Application for Amendment of Plan Under Section 12A of the Town Planning Ordinance (Cap.131) for Proposed Residential Development and Social Welfare Facility (Child Care Centre) at Various Lots in D.D. 128 and D.D. 129, and Adjoining Government Land, Lau Fau Shan, Yuen Long, New Territories (Planning Application No. Y/YL-LFS/14)

We refer to the comments from various Government departments on the captioned S12A Planning Application received between 11 April 2024 and 12 June 2024.

Application for Amendment of Plan Under Section 12A of the Town Planning Ordinance (Cap.131) for Proposed Residential Development and Social Welfare Facility (Child Care Centre) at Various Lots in D.D. 128 and D.D. 129, and Adjoining Government Land, Lau Fau Shan, Yuen Long, New Territories
 (Planning Application No. Y/YL-LFS/14)
Responses to Comments

INDICATIVE BASEMENT PLAN (B2)

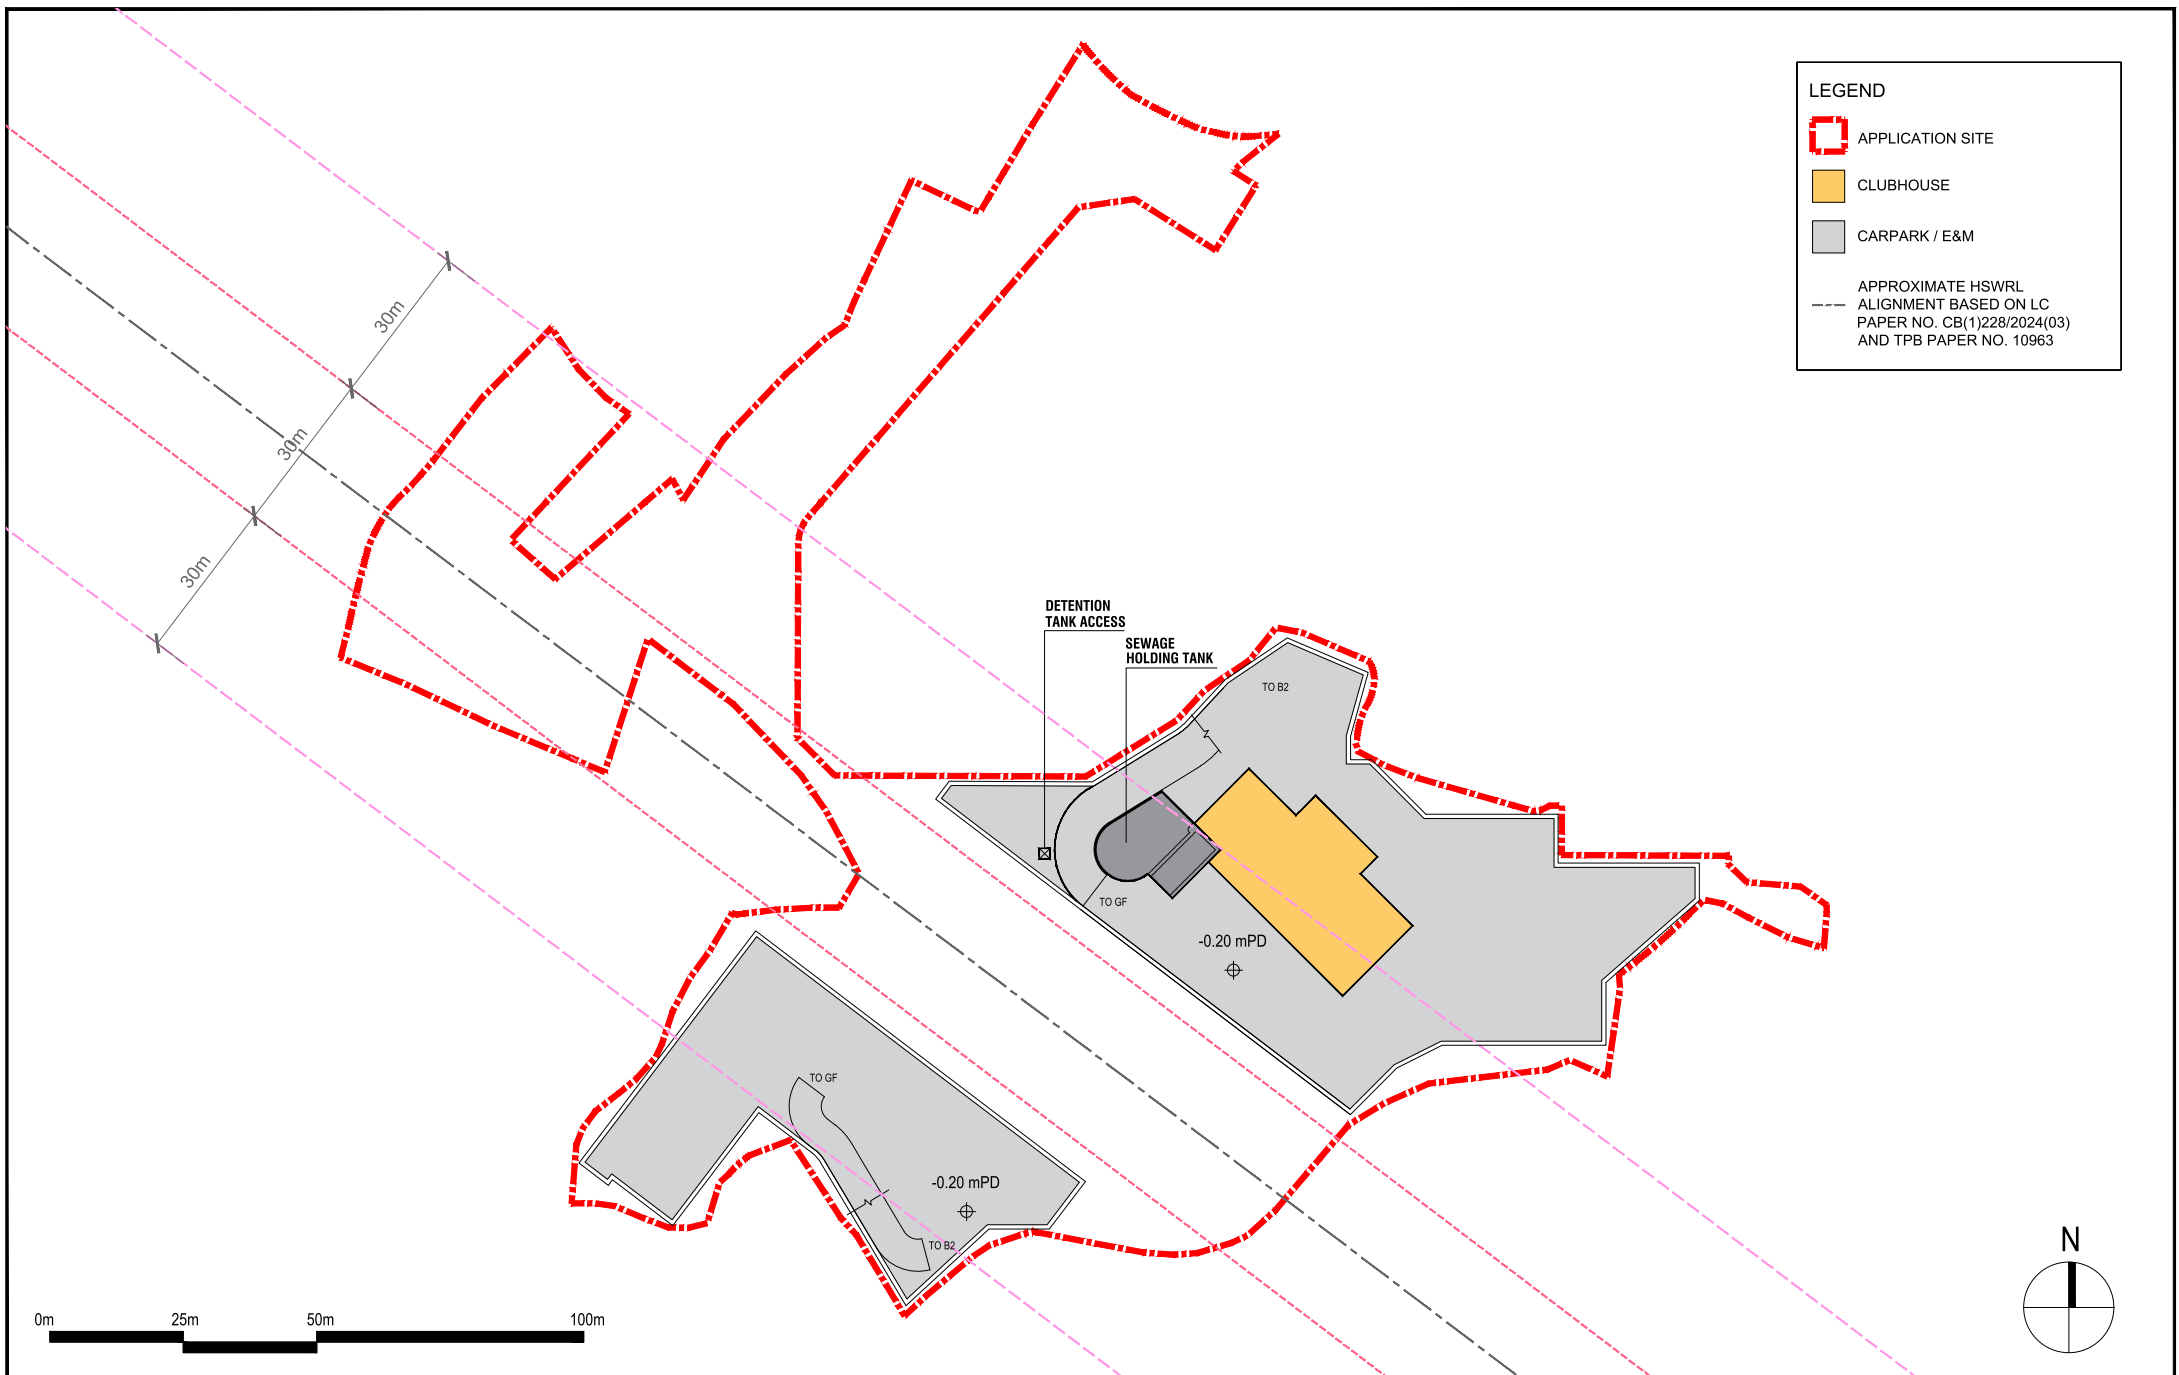
No.	Comments	Responses
	<p>development including any odour detected at the site boundary of Lau Fau Shan SPS.</p> <p>8. Section 2.4.9: Please obtain an updated complaint record for Lau Fau Shan SPS covering more recent years.</p> <p>9. Site surveys shall be conducted to verify whether any odour nuisance arises from the Deep Bay Grove RCP, which is located approximately 30 m upwind from the proposed development site.</p> <p>10. Section 2.5: - Please consider adding "avoid using exempted NRMMS" as a mitigation measure, given that several ASRs are located within close proximity (less than 10 meters) to the construction site. - Owing to the large project site area and the close proximity of ASRs, phasing of the dusty activities shall be implemented and a dust monitoring program is highly recommended during the construction phase.</p> <p>11. Section 2.5.1: Please remove "dust" in line 8.</p> <p>12. Section 2.6.1: Please revise "dust impact" in line 3 to "air quality impact".</p> <p>13. Section 5.1.2: Please add "nearby ASRs and" before "proposed development" in line 6.</p> <p>14. Please indicate on a map the locations of exhaust outlets for carparks, the sewage-related facilities and the refuse collection points. During the operation phase of the proposed development, the Applicant must adhere to relevant guidelines to ensure that these facilities do not create air and odor nuisances or impacts for the air-sensitive uses of the proposed development, or for any air-sensitive uses within the 500 m assessment area. Any exhaust outlets from these facilities should be situated away from any ASRs in the vicinity.</p>	<p>Development and at the Lau Fau Shan SPS. Survey dates in Sections 2.4.9 and 2.4.10 of Annex C have been updated.</p> <p>DSD's updated record for Lau Fau Shan SPS has been added to Appendix 2.1 of Annex C.</p> <p>An updated site survey was conducted on 12 September 2023. No odour was detected near the Deep Bay Grove RCP.</p> <p>Section 2.5 of Annex C has been supplemented to add "avoid using exempted NRMMS" as a mitigation measure.</p> <p>Section 2.4.2 of Annex C has been supplemented to recommend phasing of dusty activities and a dust monitoring program.</p> <p>Section 2.5.1 of Annex C has been revised accordingly.</p> <p>Section 2.6.1 of Annex C has been revised accordingly.</p> <p>Section 5.1.2 of Annex C has been supplemented accordingly.</p> <p>Figure 2.1 of Annex C has been supplemented to show the indicative locations of exhaust outlets from these facilities to situate away from ASRs in the vicinity as far as possible. As such, the layout of the Indicative Baseline Plan (B2) has been revised.</p>

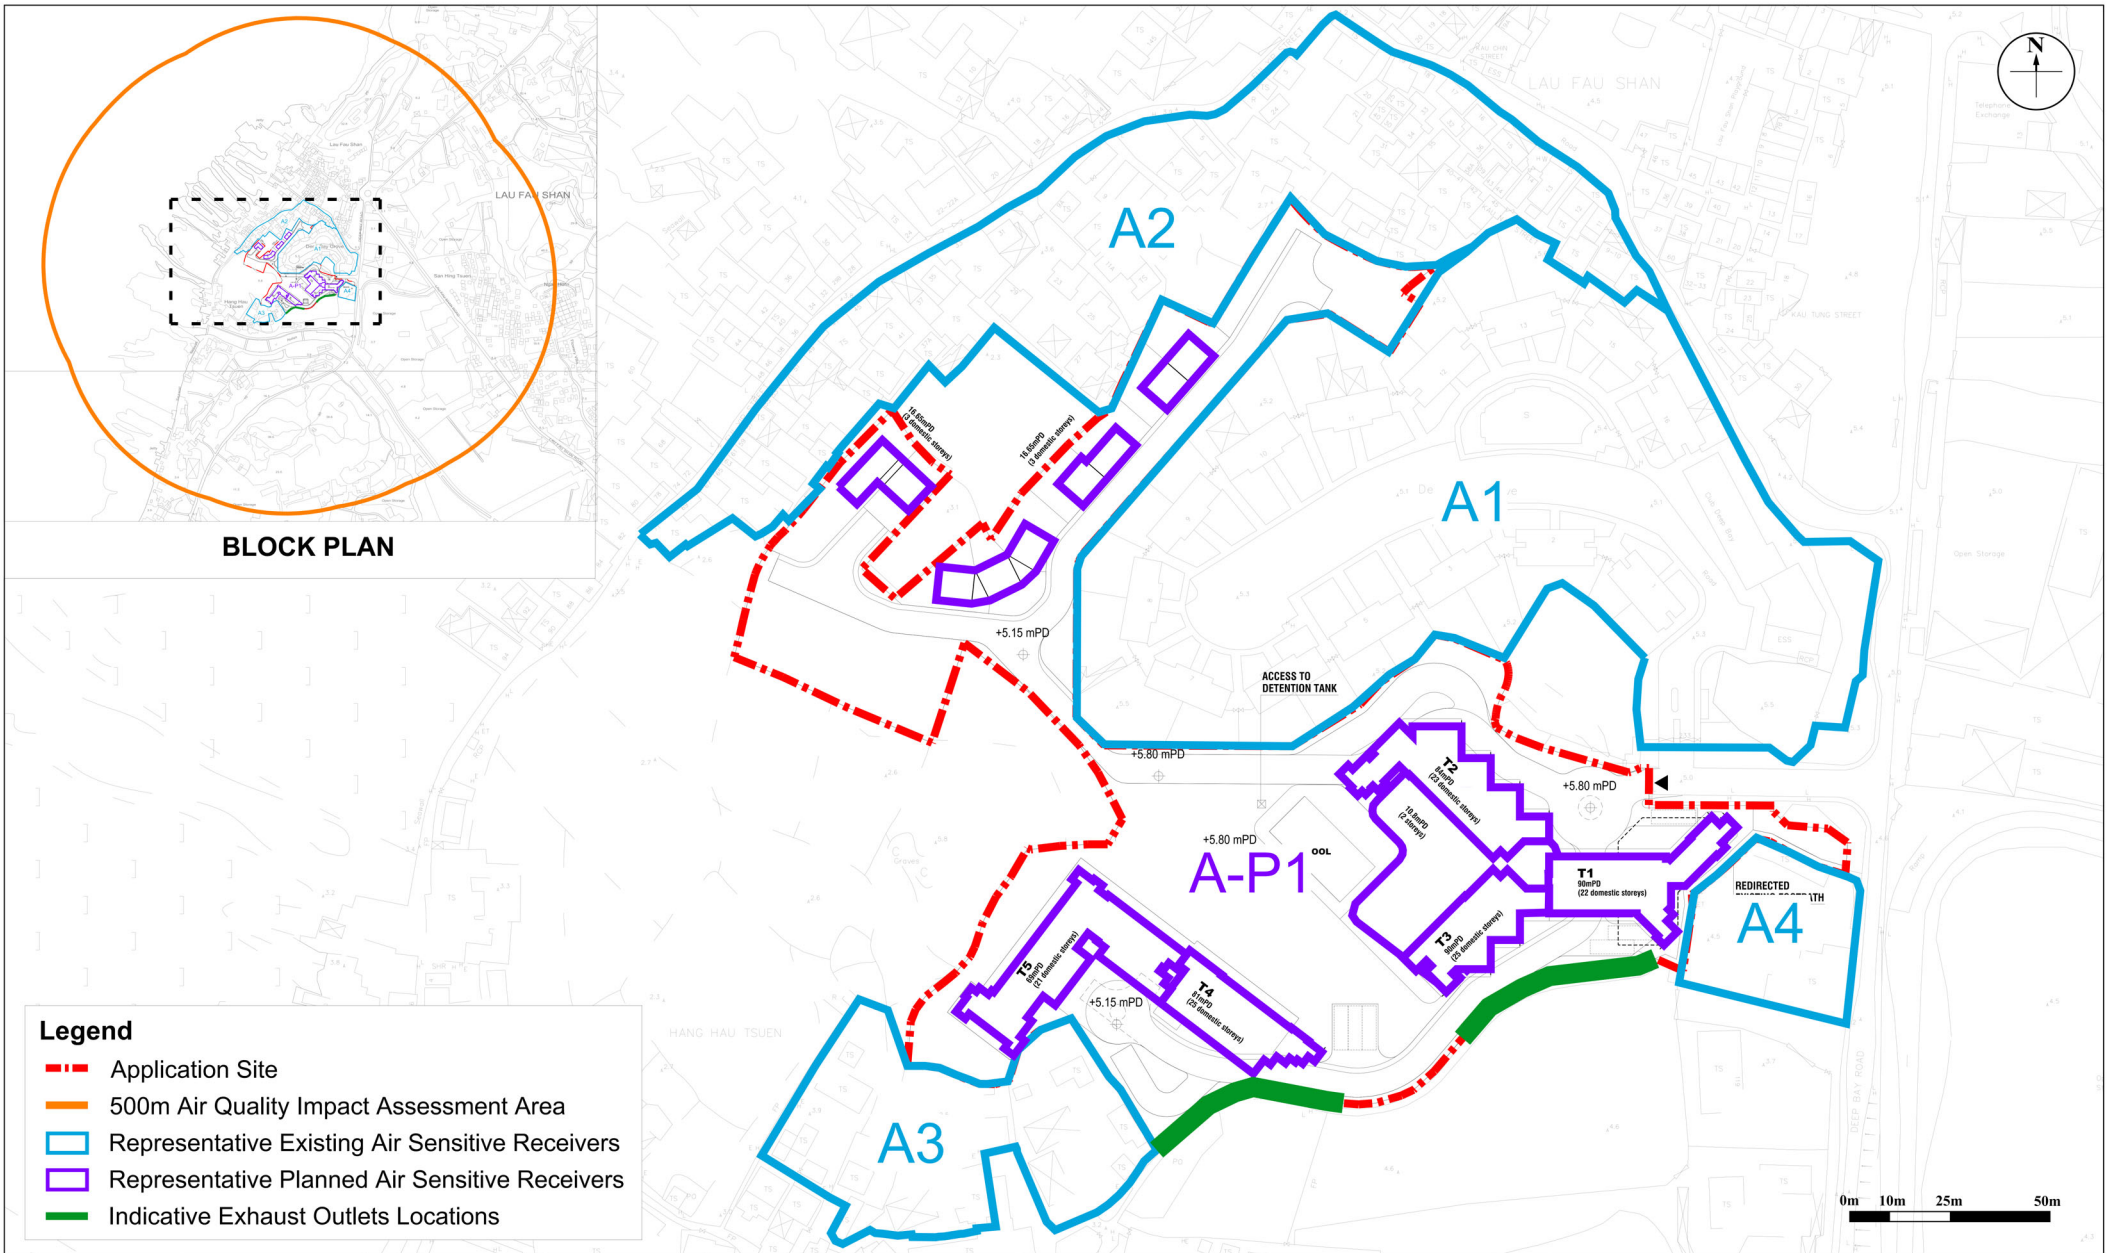
No.	Comments	Responses
	<ol style="list-style-type: none"> 1. Table 2.2 and Figure 2.1: In addition to the residential towers, the club house and the 2 clusters of houses shall also be included as planned ASRs. 2. Section 2.4.2: Please provide the excavation area and the amount of excavated materials to be handled to justify that the scale of work is small. 3. Section 2.4.3: Please provide the number of construction trucks and mechanical equipment to be used per time over the work site to justify that the number of construction plant required on-site is limited. 4. Please clarify whether there are any concurrent projects within the 500 m assessment area and whether cumulative air quality impact shall be assessed. 	<p>Table 2.2 and Figure 2.1 of the replacement pages of the Environmental Assessment (Annex C) have been revised to supplement the club house and the 2 clusters of houses as planned ASRs.</p> <p>It is estimated that the area of excavation is about 8,489 m², and the amount of excavated material to be handled is around 400 m³ per day. Section 2.4.2 of Annex C has been supplemented to provide such information.</p> <p>As the project is still in early planning stage, detailed construction information is not available at this stage. Section 2.4.3 of Annex C has been revised to avoid confusion.</p> <p>No, there are no concurrent projects within the 500m assessment area of the Proposed Development. Although the site formation and engineering infrastructure works of HSK/HT NDA Second Phase development is planned to commence in 2024 for completion by 2030, its works boundary is outside the Proposed Development's 500m assessment area (see extract of LC Paper No. CB(1)48/2024(03)). The programme of the remaining phase development is uncertain yet. Hence, adverse cumulative air quality impact is not anticipated.</p>

Title: Buffer Distance from Surrounding Road Networks

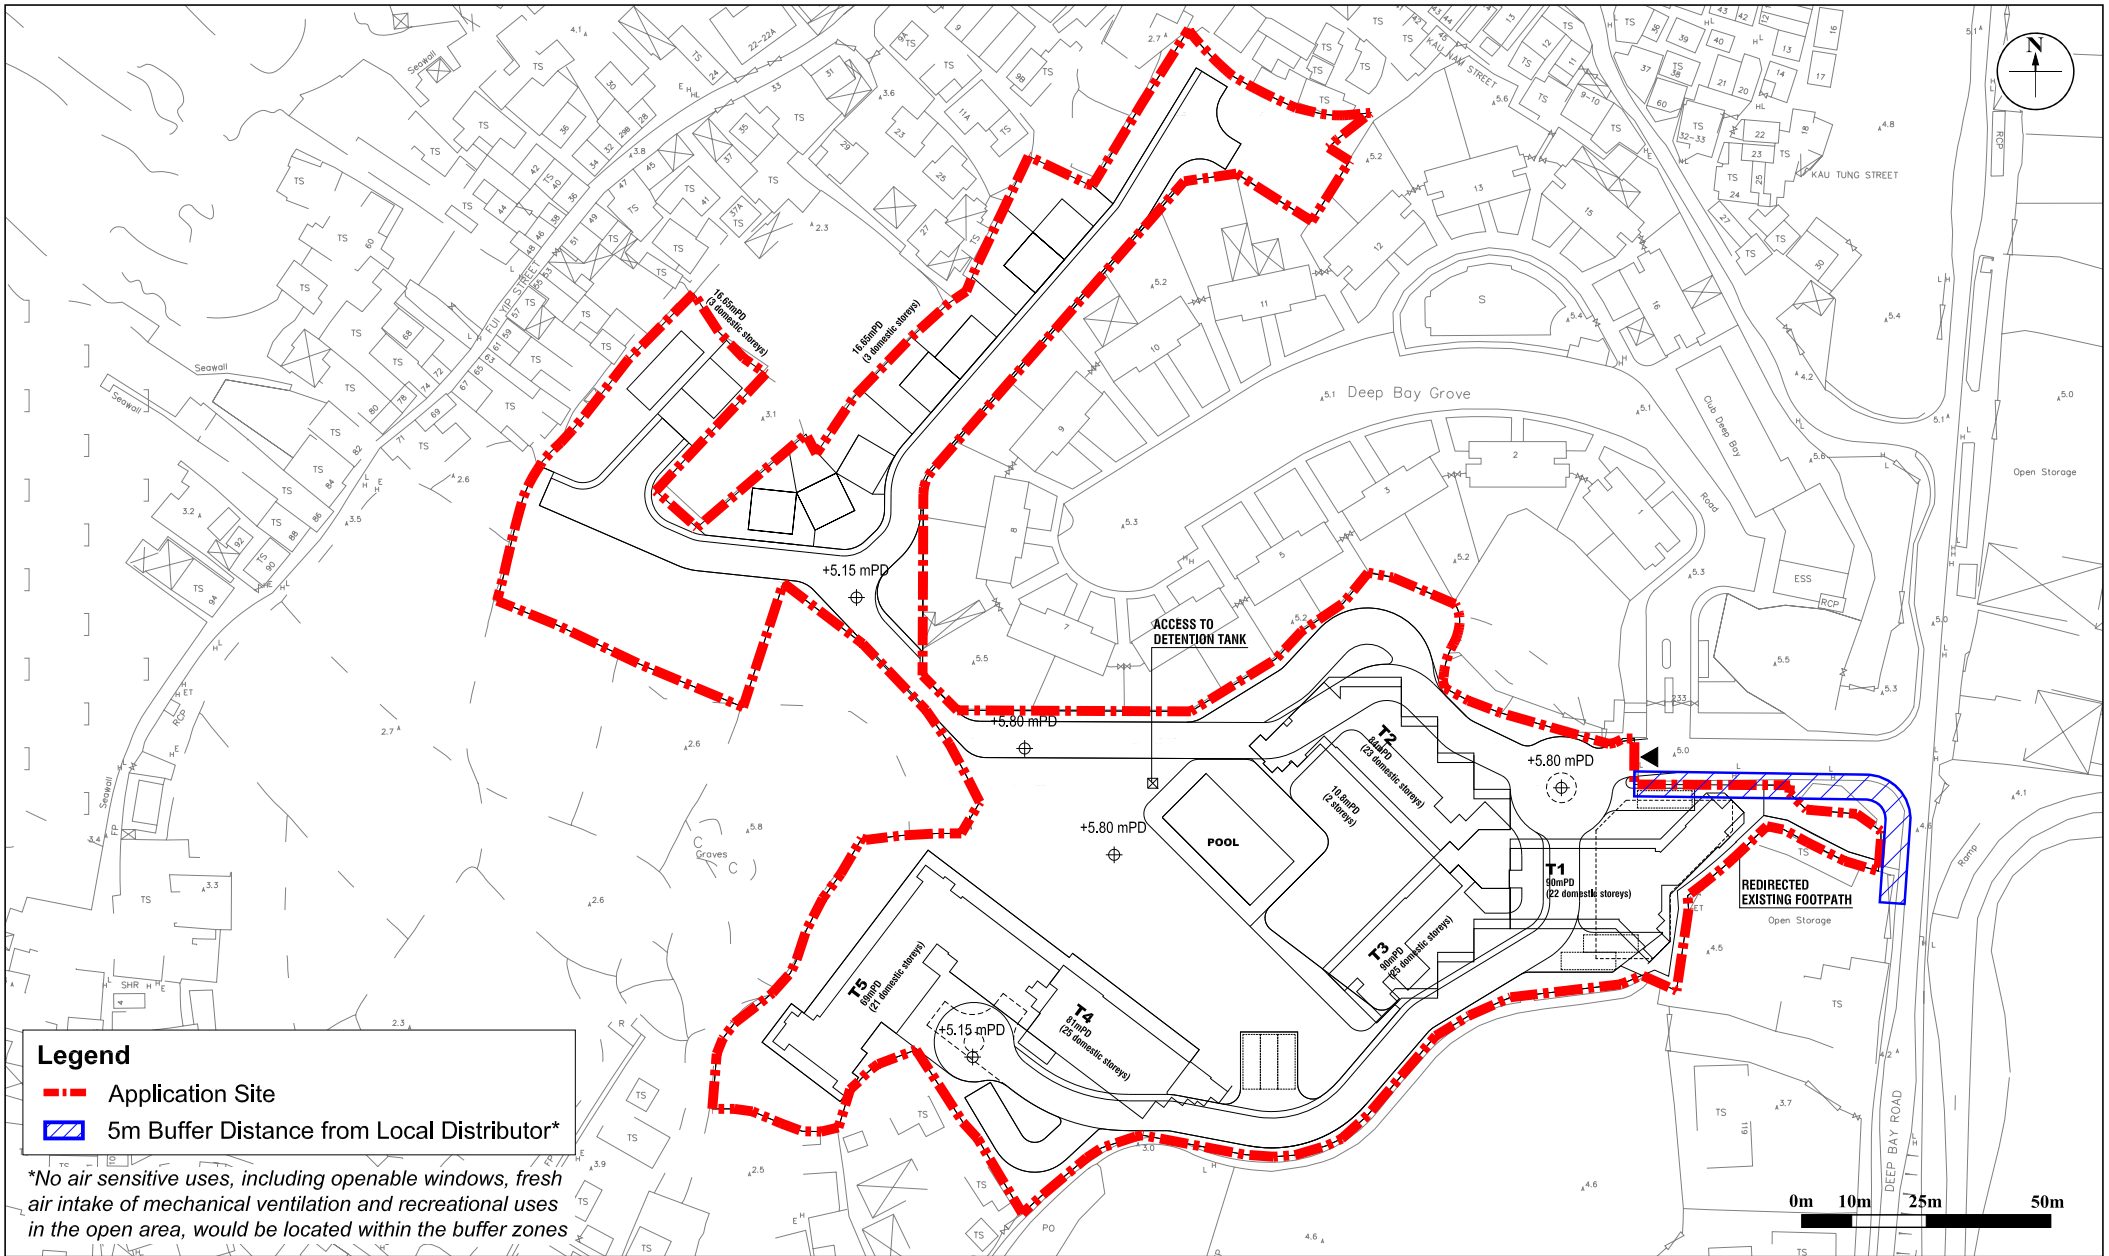
No.	Comments	Responses
	<p>15. Figure 2.2:</p> <ul style="list-style-type: none"> - Please add a remark to state that "no air sensitive uses, including openable windows, fresh air intake of mechanical ventilation and recreational uses in the open area, would be located within the buffer zones". - Please delete "Rural Road/" in the legend. 	<p>Figure 2.2 of Annex C has been supplemented and revised accordingly.</p>
<p>3.</p>	<p>Environmental Protection Department, Environmental Assessment Division, Territory North Group, Yuen Long, dated 12 June 2024</p> <p><u>Noise</u></p> <p>It is noted that the applicant submitted FI involving substantial changes to the indicative development scheme. According to the updated EA, the predicted traffic noise and fixed noise would comply with the noise criteria and requirements under HKPSG and NCO. Given practicable and feasible noise mitigation measures could be available, from noise planning point of view, we shall maintain <u>no objection</u> to this planning application provided that there is a mechanism, e.g. lease condition, to require the applicant to submit a proper NIA report to review, explore, demonstrate and implement noise mitigation measures for full compliance with the relevant noise criteria and requirements under ProPECC PNs, HKPSG and NCO. The following <u>advisory suggestions</u> are provided to the applicant/consultant to facilitate the integrity and appropriateness of their future submission, if any, as appropriate.</p> <ul style="list-style-type: none"> • S.4.3 & S.4.7 - Given fixed noises is controlled under NCO, to prevent NCO implication and also for avoidance of doubt, a new paragraph should be added after S.4.3.4 as "To ensure the fixed plant noise generated by the Proposed Development would not cause excessive impact to nearby noise sensitive receivers, potential fixed noise sources within the Proposed Development shall be properly designed to meet the relevant noise criteria as stipulated in Chapter 9 of the HKPSG and NCO. 	<p>S.4.3.5 of Annex C has been supplemented to avoid confusion.</p>
